CABINET MEMBER FOR ENVIRONMENT – 21 MAY 2020

ABINGDON – NORTHCOURT ROAD: PROPOSED AMENDMENTS TO TRAFFIC CALMING MEASURES

Report by Interim Director of Community Operations

GENERAL ARRANGEMENT DRAWING SHEET 1 OF 2

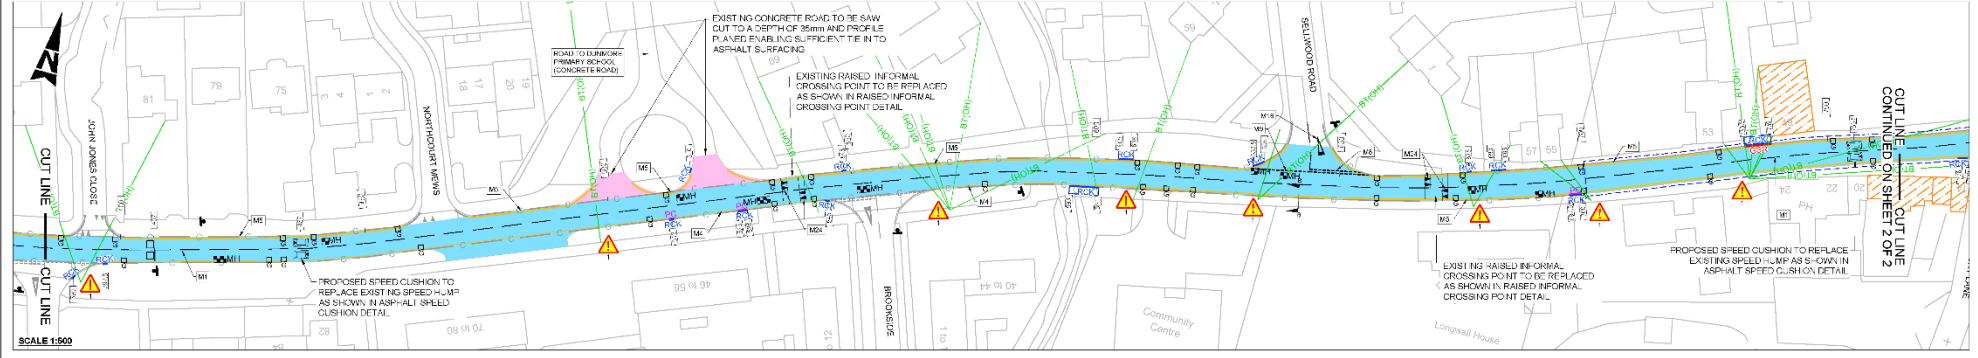
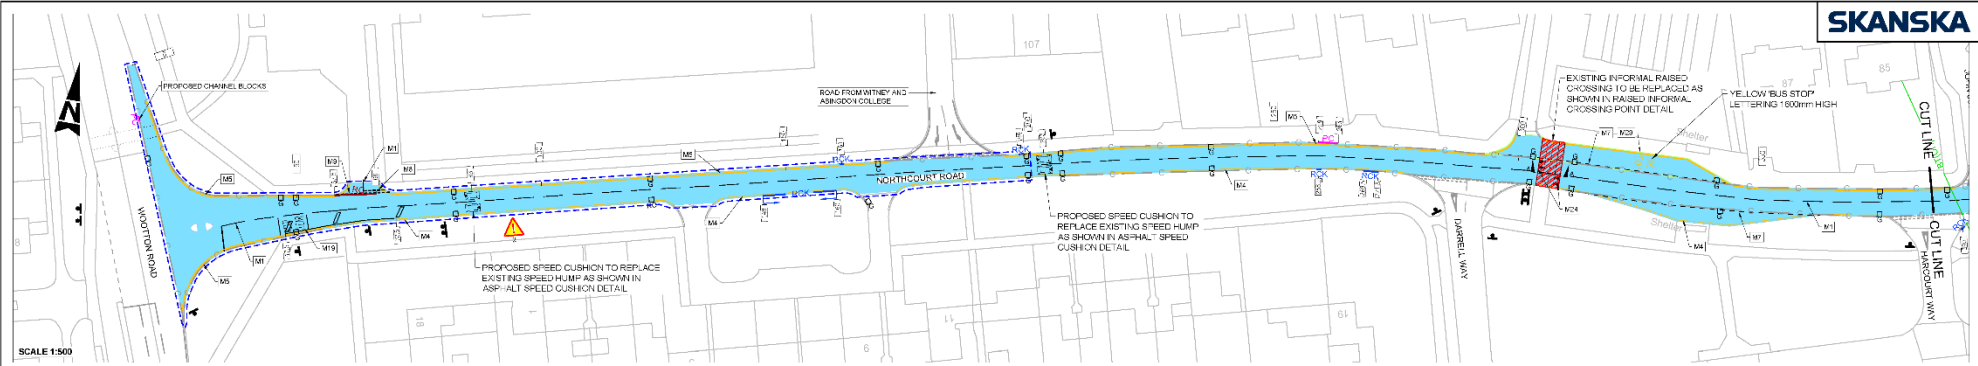
6. Thames Valley Police did not object but noted that speed cushions would not present as much of a restraint to speeding by motorcycles as compared to the current traffic calming comprising full width road humps.

7. The Vale of the White Horse District Council did not object.
8. The Oxford Bus Company supported the proposals noting that the road is used by buses as part of an emergency diversion route and requested that the speed cushions should be of a 'bus friendly' design.

9. Dunmore Primary School while expressing support for the overall scheme also expressed concerns over the lack of a formal pedestrian crossing point by the school as opposed to the current informal raised crossing point, noting the large number of students and parents who cross the road each school day.

10. The Oxford Cycling Network objected and requested that consideration be given to closing the road to motor vehicles at a suitable point to prevent through motor traffic, while still providing full access to the road either side of the closure point to all vehicles requiring access and also requested that a 20mph speed limit should be introduced in the area, to include Northcourt Road and adjacent roads.

11. The remaining sixteen responses were from members of the public. Seven were objections, six expressed concerns and three expressed support, although included in the latter were concerns that cushions may damage car tyres and also that wider measures were needed to address traffic problems in the area.

12. The grounds for objection and concern were that the scheme would not fully address the traffic issues on the road and that further measures were needed including a road closure, a 20mph speed limit and formal crossings by the schools. However, some respondents were concerned about increased emissions arising from traffic calming measures and pointed to the need for speed enforcement as a more suitable way of addressing excessive speed. Additionally, concerns were raised that the existing traffic calming was used by some drivers to facilitate driving onto the grass verges to park.

13. Noting the above responses, it should be stressed that the proposals comprise relatively small changes to the road layout as part of a major maintenance scheme and that there is no funding currently to progress the wider measures sought including for example the formal crossings or 20mph speed limit. Noting the above the scheme, however, in no way precludes further measures being brought forward subject to funding being available and should also help address some of the concerns raised over the operation of

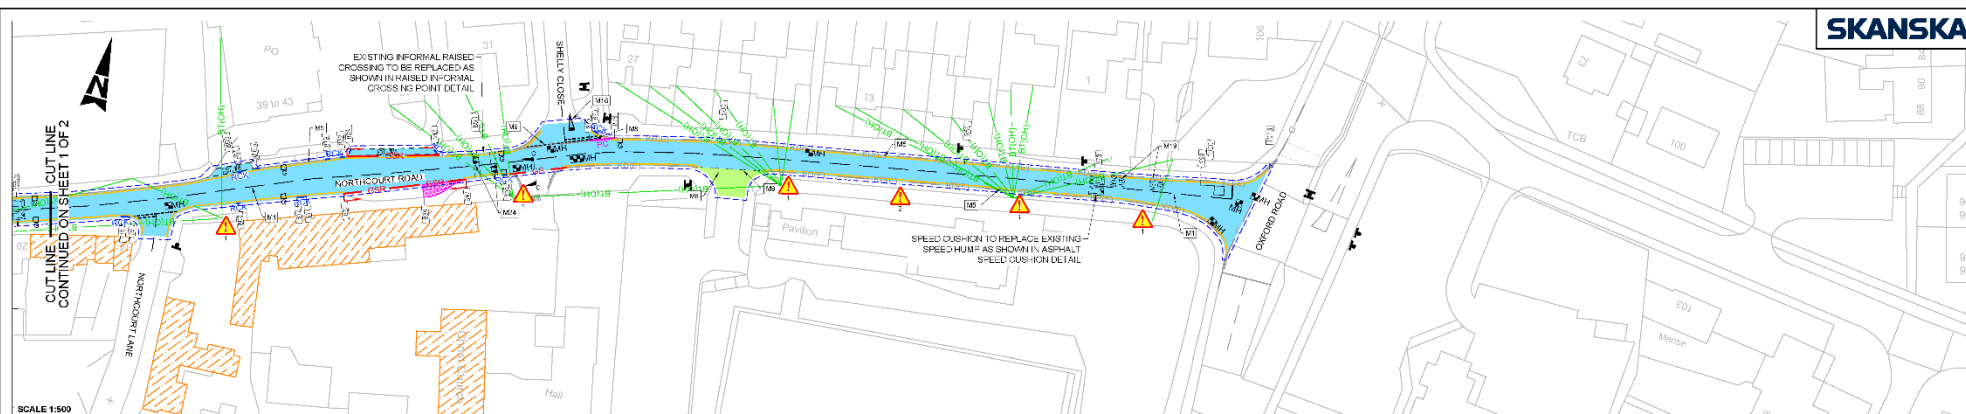
U1	06.02.20	Speed Cushion dimensions amended	AKM/SJM
DD	30.09.19	Detailed Design	JE JS
Rev	Date	Description	Rev. 2/3/4
